P93-138 - JACK-IN-THE-BOX (Continued from December 9, 1993)

REQUEST: A. Negative Declaration
 B. Mitigation Monitoring Plan
 C. Special Permit to allow drive-up service for a Jack-in-the-Box restaurant.

LOCATION: 1901 J Street (NE corner of 19th and J)
 Parcel Number: 007-0014-015
 Central City Community Plan area
 Council District 3

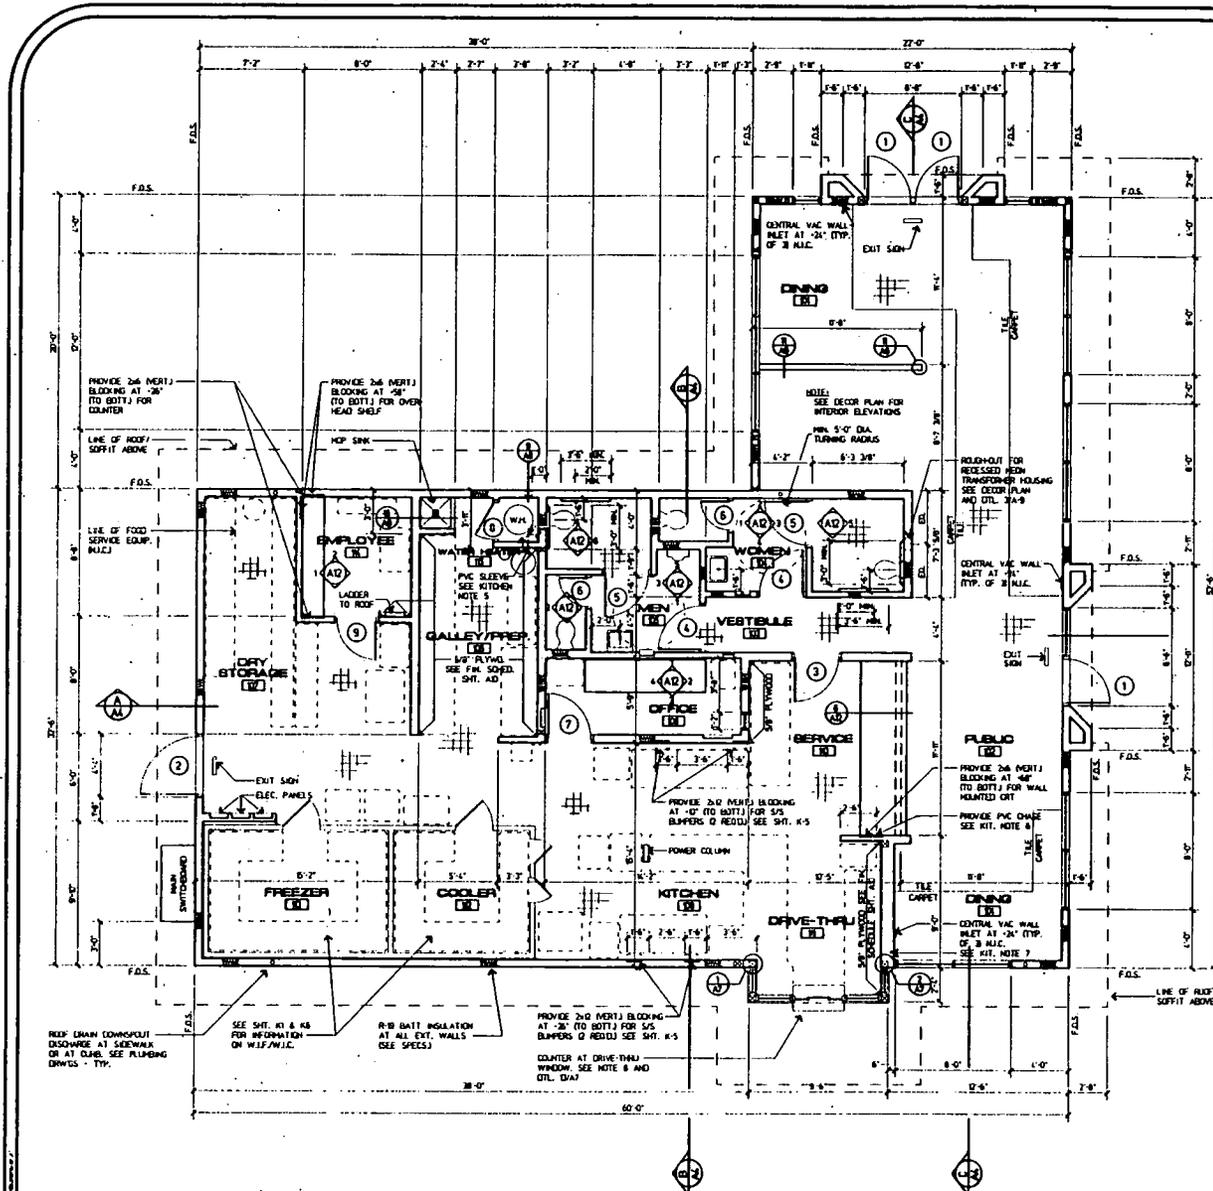
Vehicular access to the project would be provided via J Street and the alley to the rear of the site. All existing curb cuts will be removed, and a new curb cut and driveway established at the southeast corner of the site along J Street. The project is very much oriented to the automobile in that it proposes drive-up window service, requiring a lengthy drive-through lane for adequate stacking of vehicles.

Traffic Engineering has concerns that the drive-through lane, with its exit near the driveway on J Street, may result in conflicts with the one-way traffic on J Street. Consequently, they recommend that the drive-through be redesigned so that vehicles will exit onto 19th Street instead of J. In addition, the parking lot should be reconfigured so that spaces are a minimum of 50 feet from the J Street right-of-way (curb).

Traffic has concerns that the proposed drive-through lane, with its exit near the driveway on J Street, will result in traffic conflicts and, therefore, recommends that the project be redesigned by reconfiguring the drive-through so that vehicles will exit onto 19th Street. A revised plan shall be submitted prior to the Planning Commission granting approval of the Special Permit.

Fire has concerns that the driveway on J Street will create traffic conflicts on J Street, thereby resulting in a delay of emergency fire and ambulance response time.

If the Planning Commission wishes to approve the Special Permit to allow the drive-up window, staff recommends that the project be sent back for redesign of the site circulation and parking. Staff will then bring the revised plans back before the Planning Commission for final approval.

Exhibit C-3 Elevations

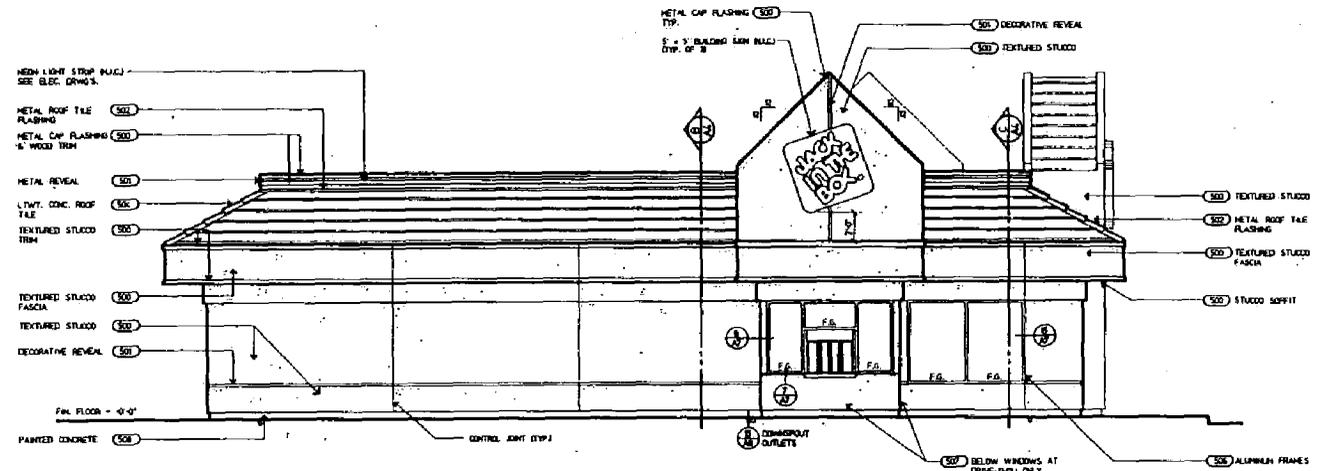
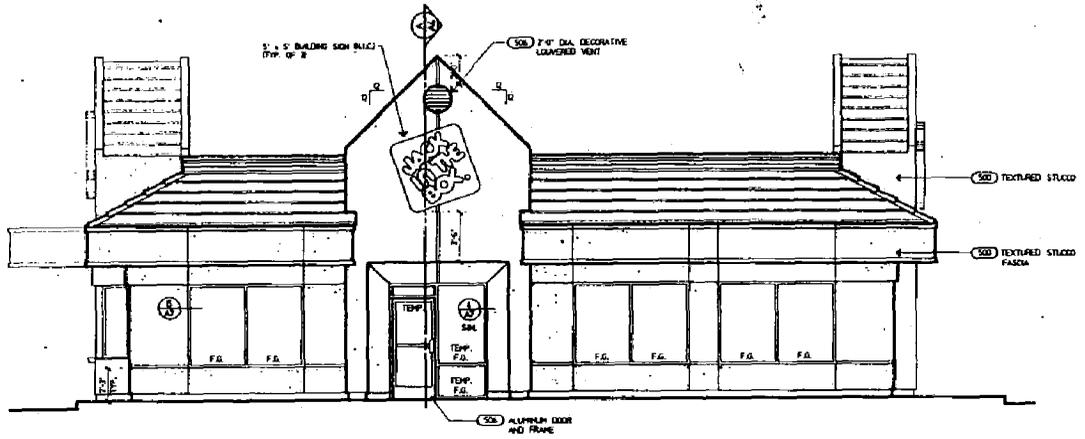
The project will include a number of signs. While the elevations depict three attached identification signs, each measuring 25 square feet in area, the building may have only two attached identification signs, per Section 3.66 of the Sign Ordinance. Such signs may be a maximum of three square feet for each front foot of building occupancy. Since the building is located on a corner, each street frontage may have signage, thus one may face J Street on the front and 19th Street on the side. Each sign will measure five feet by five feet, for an area of 25 square feet, and a total area of 50 square feet, well within the maximum allowable.

The project is designed in a contemporary theme, with exterior materials consisting of white stucco, aluminum windows having a bronze finish, and dark grey concrete tile roofing. Staff has concern with the design in that it does not complement the character of the area in terms of its scale, massing, or appearance. A more appropriate design would be a two-story commercial or mixed use structure such as can be found elsewhere on J Street or Midtown, as noted above under Policy Considerations.
